RE: IFB Canyon Del Oro HS N Gym HVAC Conversion 1042022CDO

Amendment 1
Amphitheater Public School
17.14.73 CDO High School – North Gym HVAC Replacement

AMENDMENT ONE – Date: October 7, 2022

KWA Addendum #:	1	Date:	October 3, 2022
Project:	CDO North Gym HVAC Conversion	KWA Project #:	21030
Architect:	Breckenridge Group	Architect's Project #:	17.14.73
Owner:	Amphitheater Public School District	Owner IFB#:	1042022CDO

Reflected Ceiling Plan
A2.1

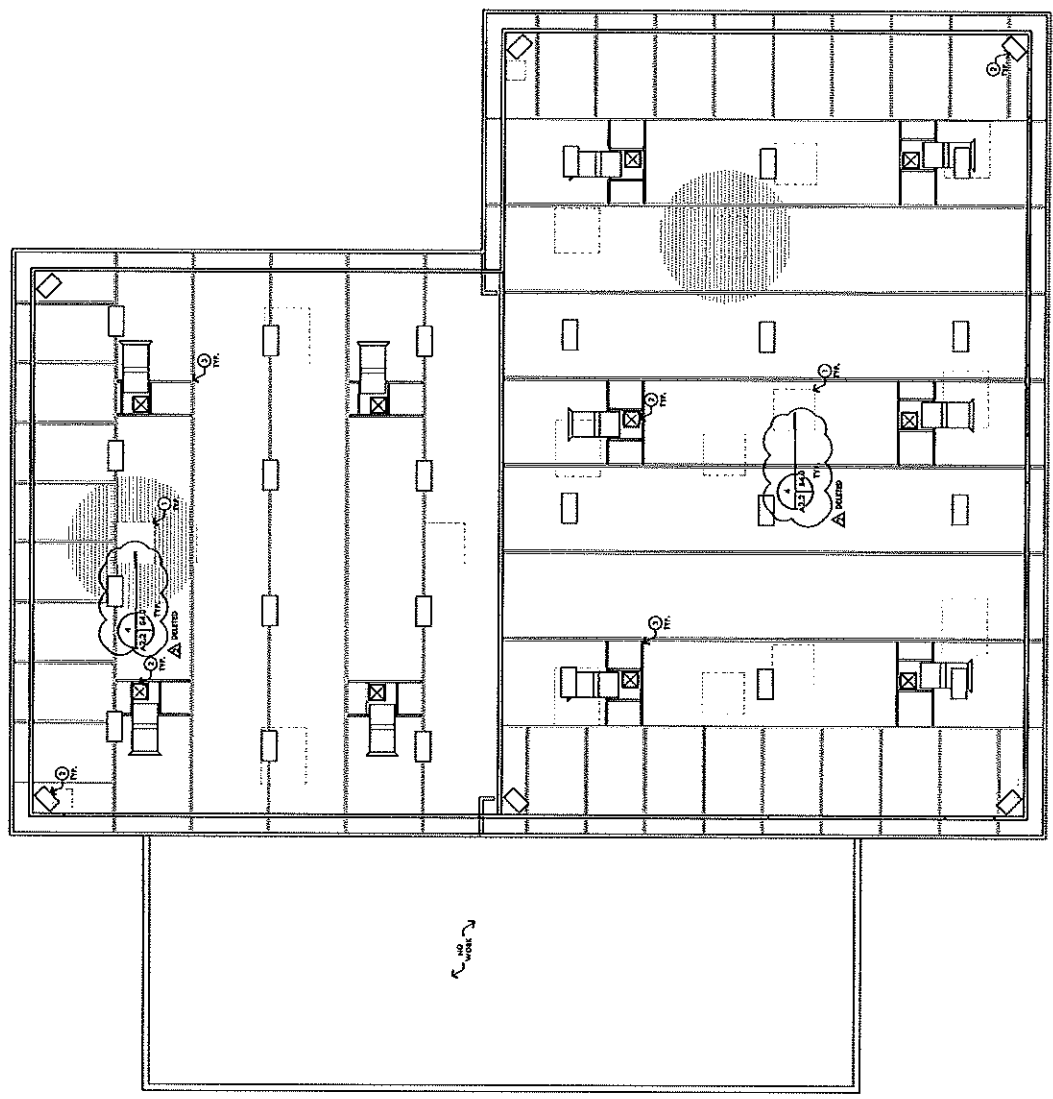
1. Clarification: Sheet A2.1 – ceiling patch work is removed, all work associated with structural detail 4 is removed from scope
2. Clarification: Sheet A2.2 – roof patch work is removed. (E) curbs to remain.
3. Clarification: Sheet A10.1 – detail 5 removed, detail 11 added, detail 4 modified
4. Clarification: Sheet M4.1 – note addition
